Design Review Board Meeting

Tuesday, November 14, 2023, 3:00 PM

Below is a summary of the comments addressed from conceptual DRB review of DPB-001710-2023 – 20 Olive Shell Court, Olive Shell Cottages Development. Sheet set dated November 8, 2023.

DRAWING NUMBER
L100

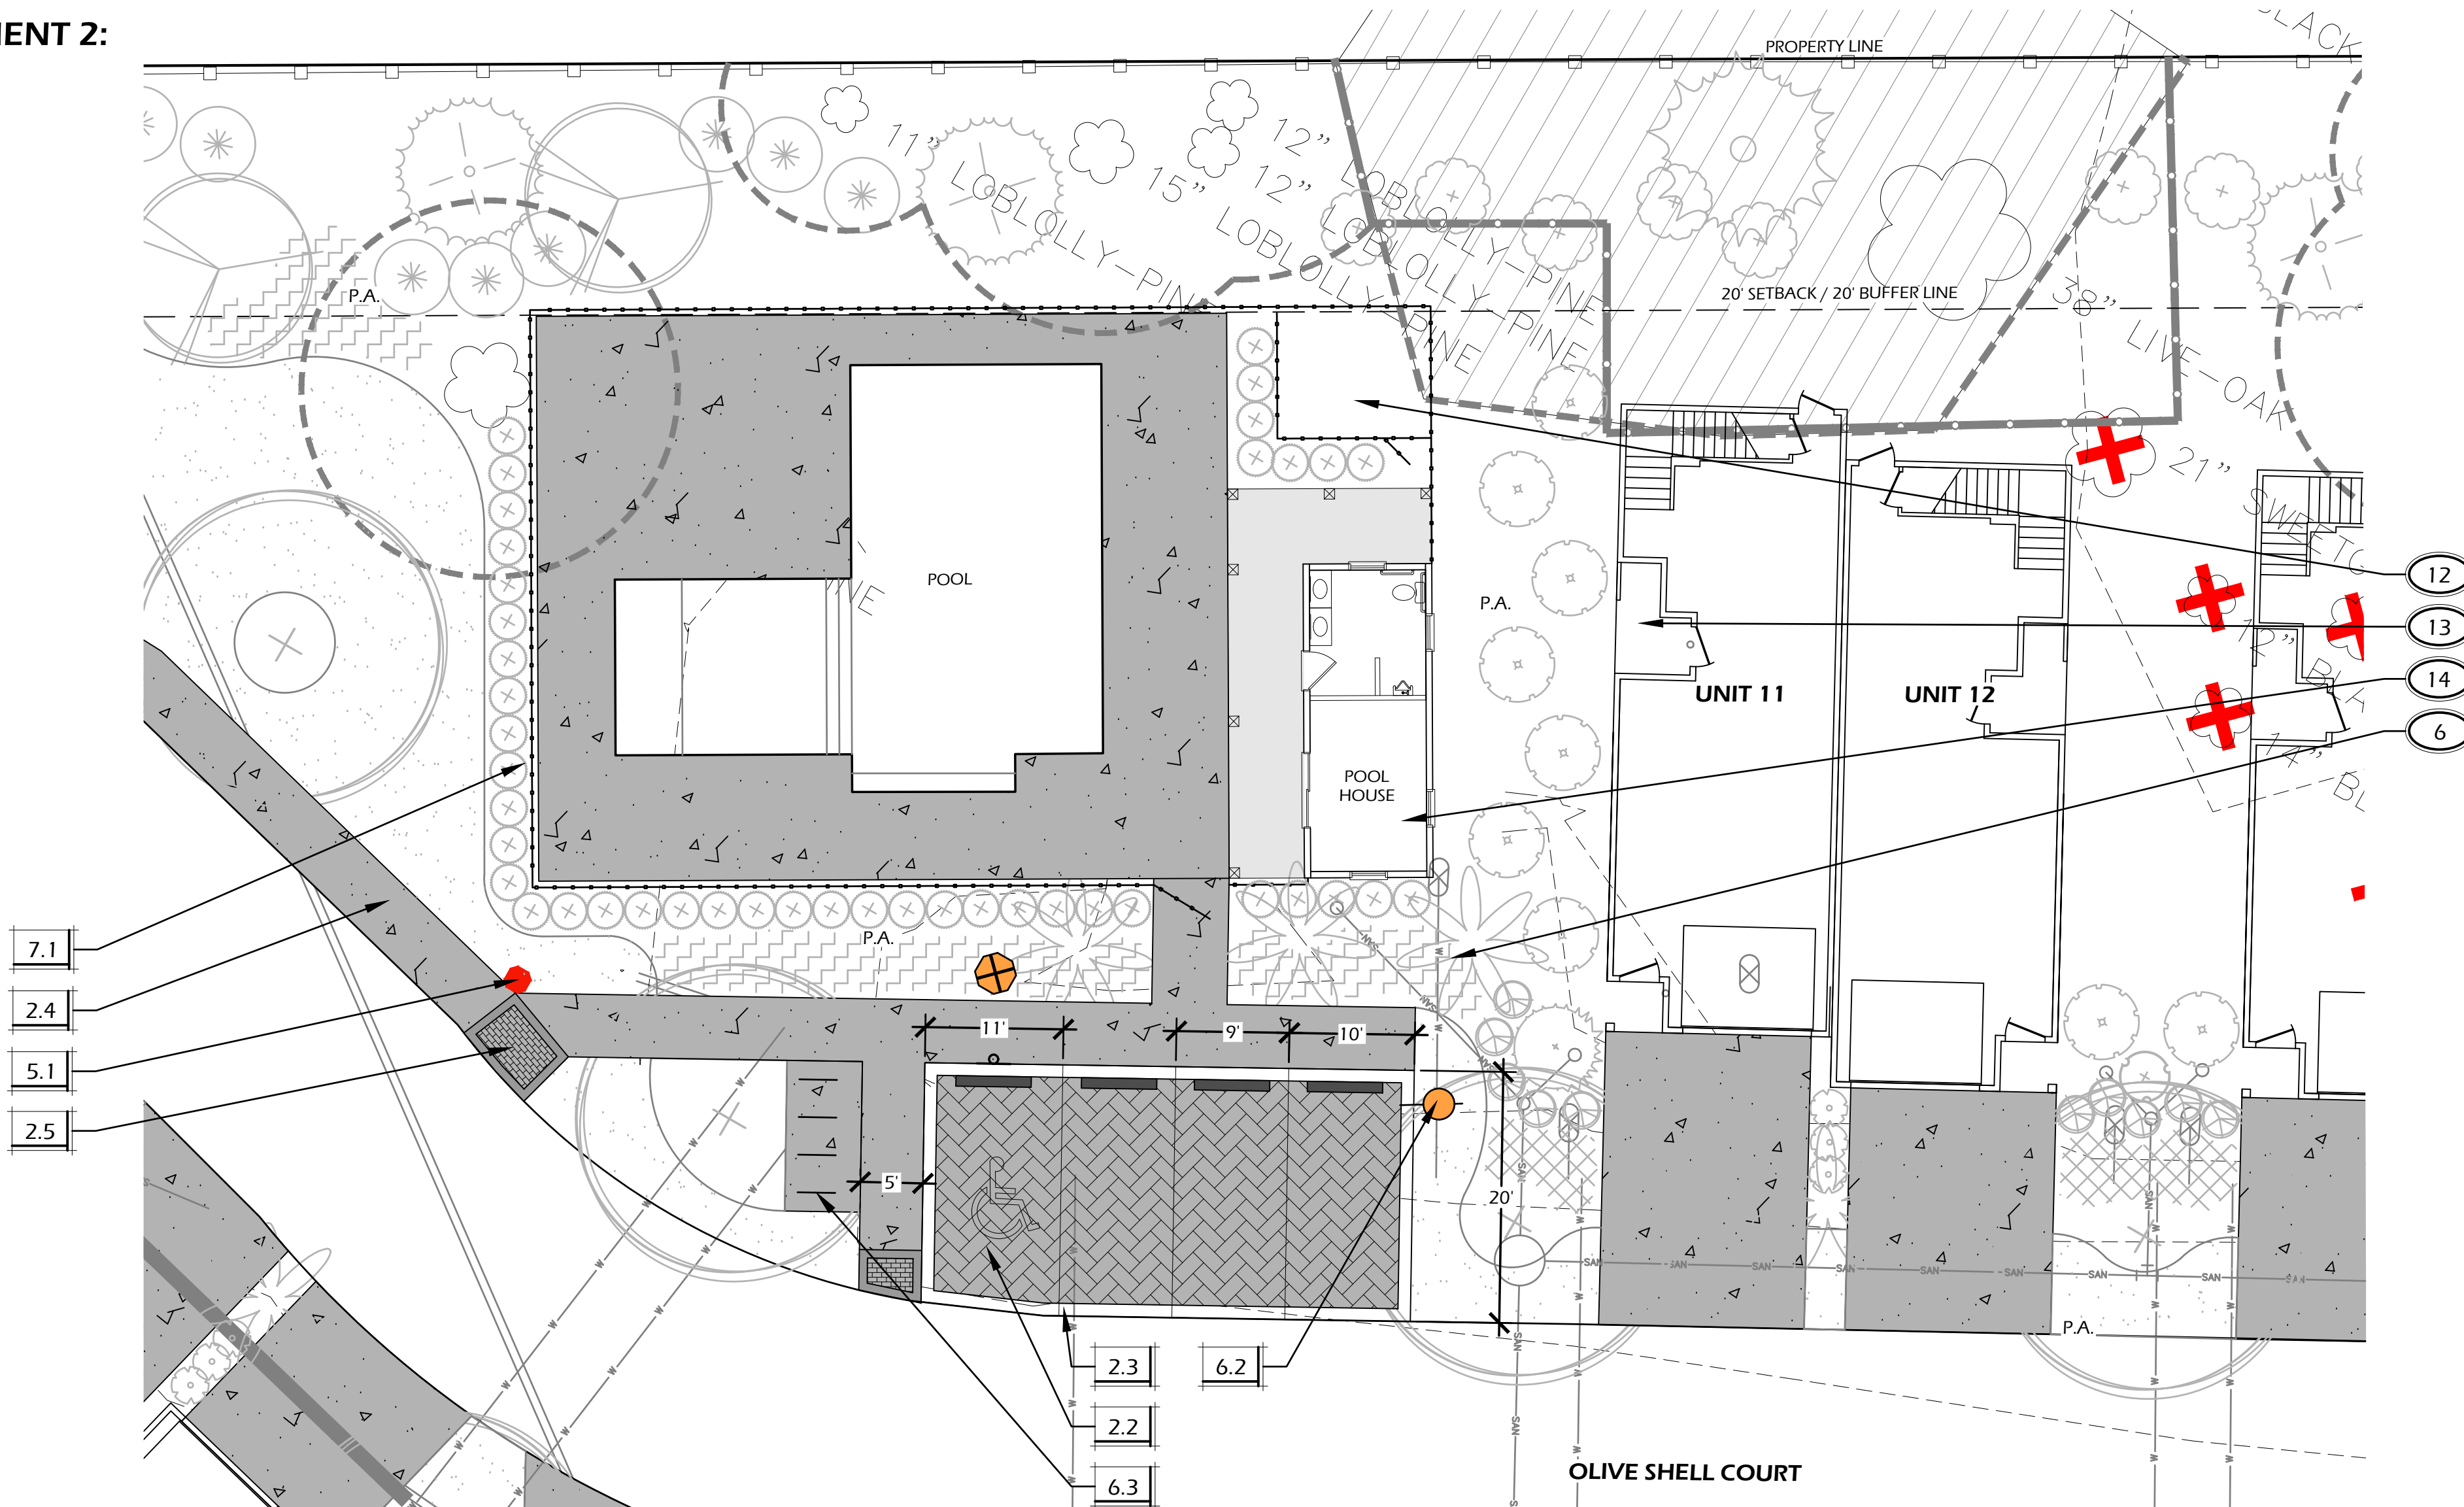
L100 – Concrete sidewalk extended to pool amenity (DRB Condition #1). Shifted bike racks with sidewalk expansion (DRB Condition #2). Stormwater channel adjacent to specimen live oak is an existing condition (DRB Condition #6). Accurate duplex footprints shown with stagger (DRB Condition #8 & #11). Street light locations added to plan (Note #12).

DRAWING NUMBER
L101

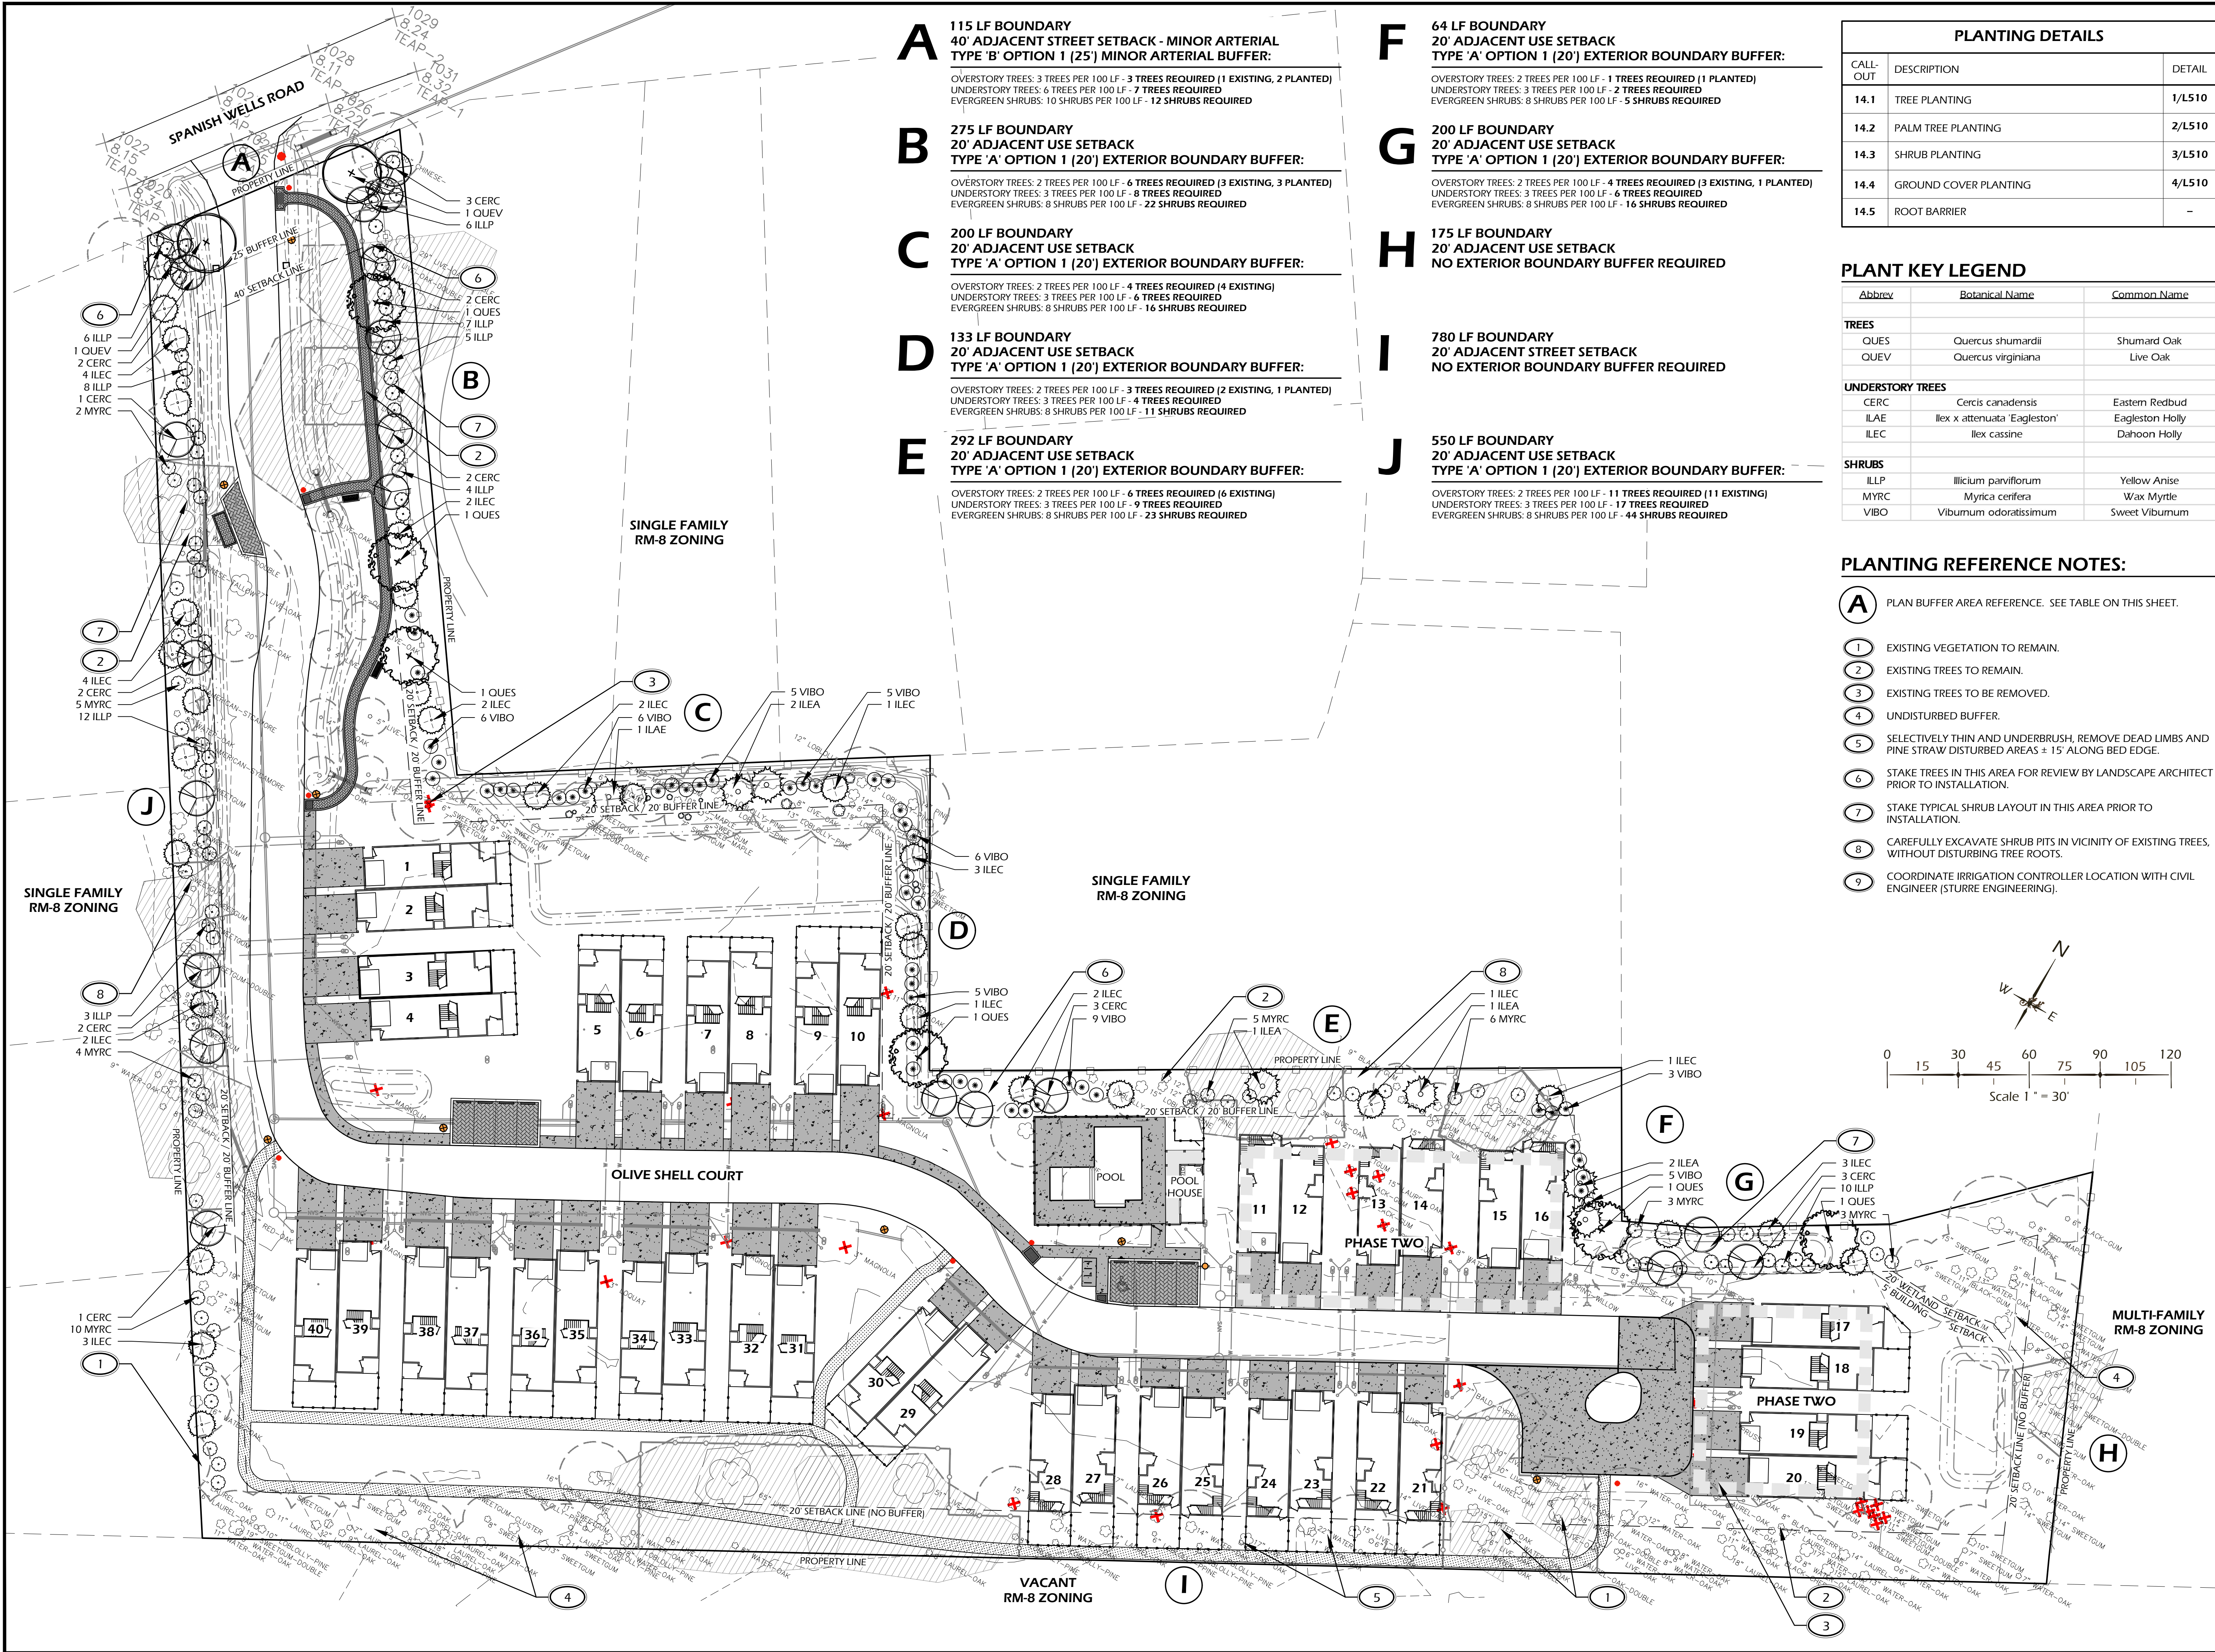
L101 – Sheet added to show more plan information for Mail Kiosk area and Pool Amenity (DRB Board Comment).

2 // L601 MAIL KIOSK
SCALE: NTS

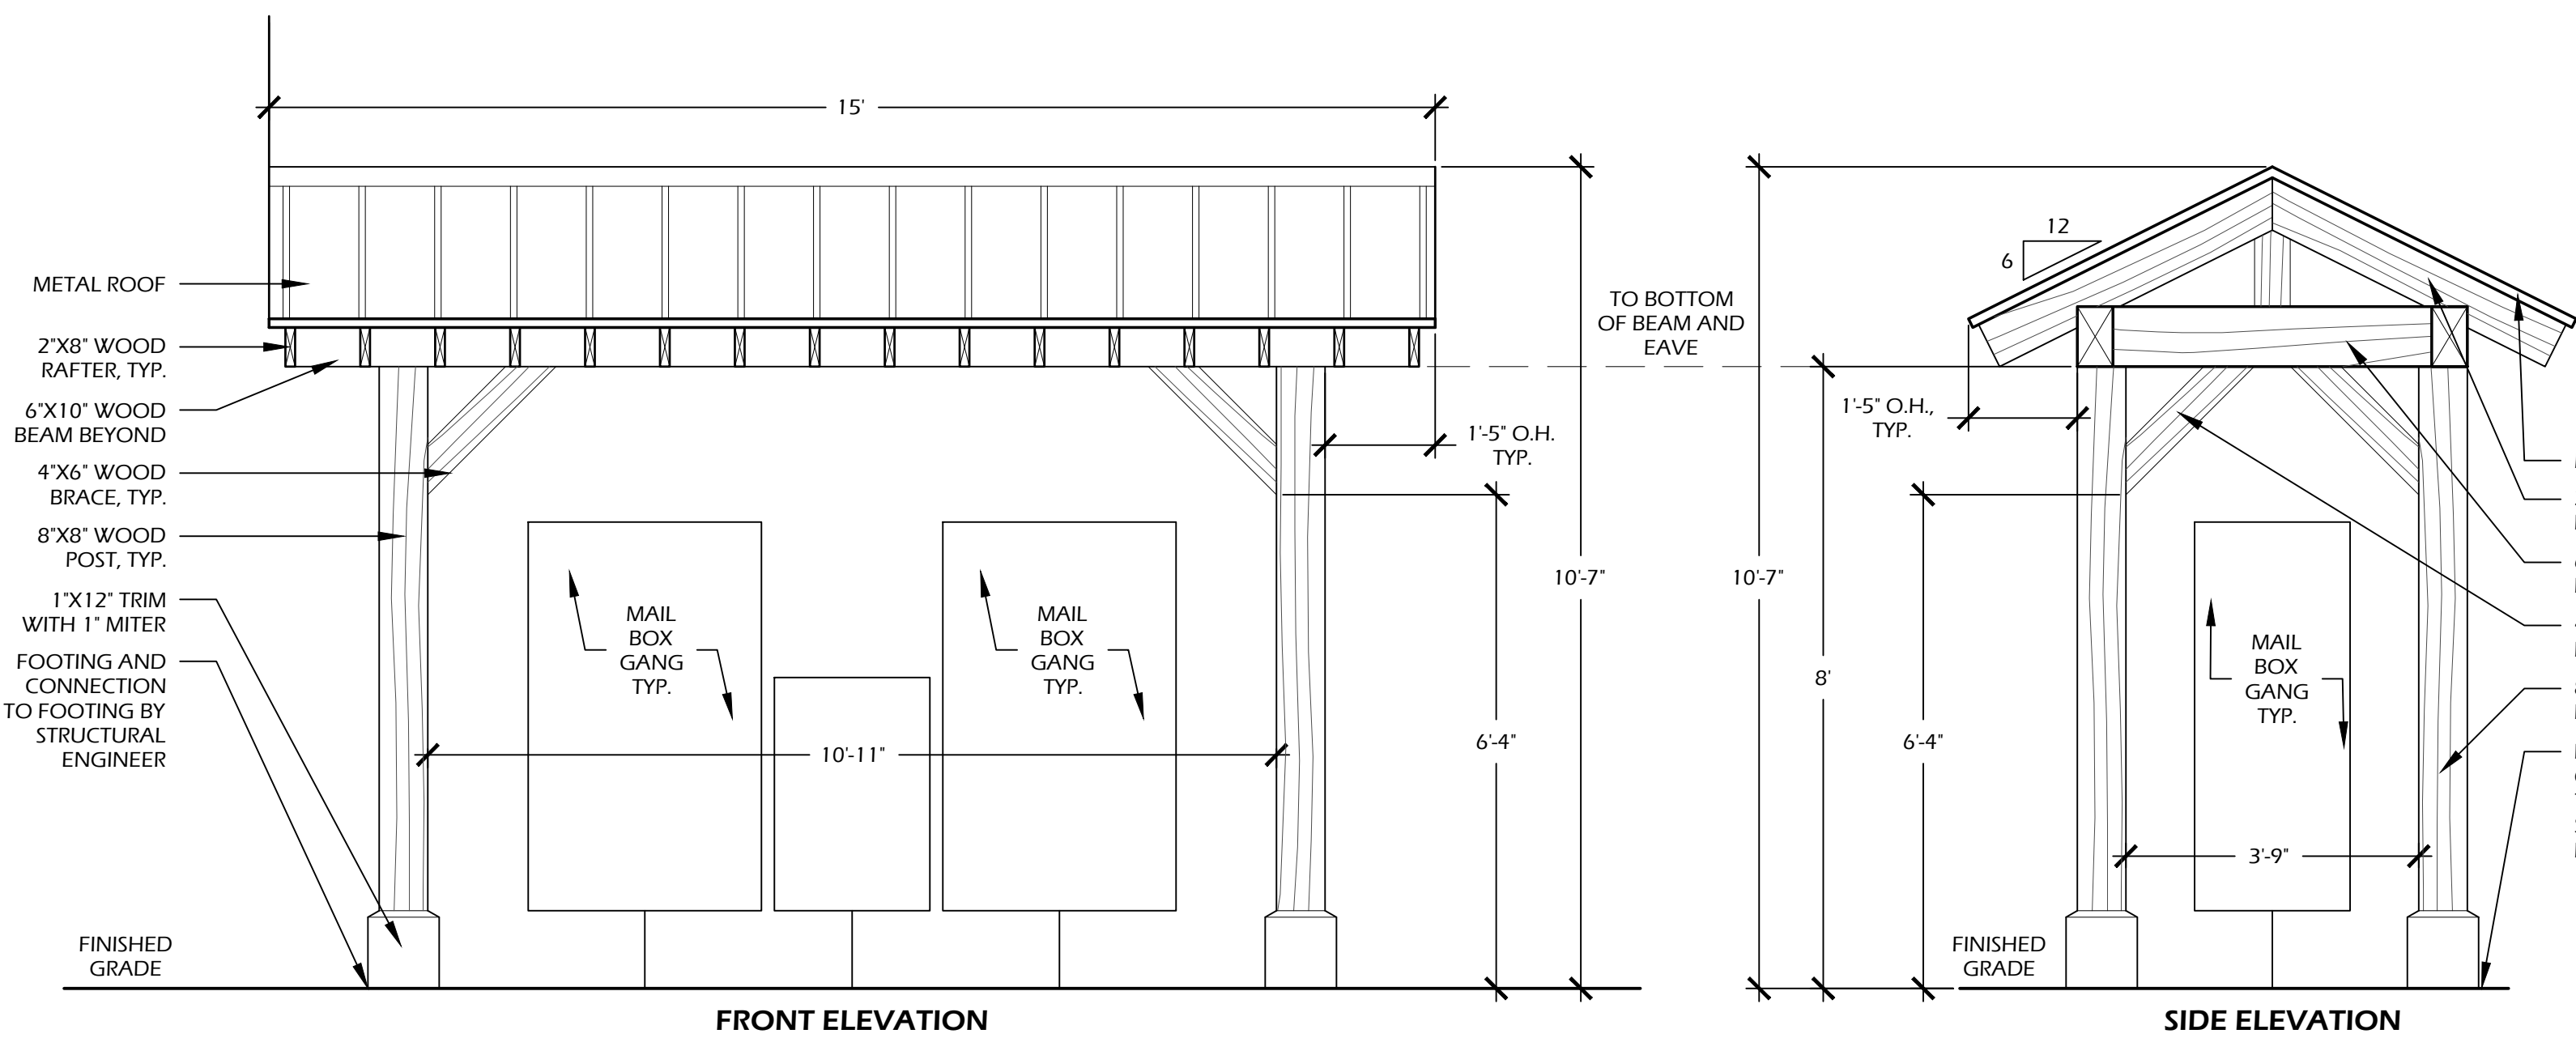
L601 – Mail kiosk detail revised to include more detail and better massing than prior photo – see detail 2/L601 (DRB Condition #7).
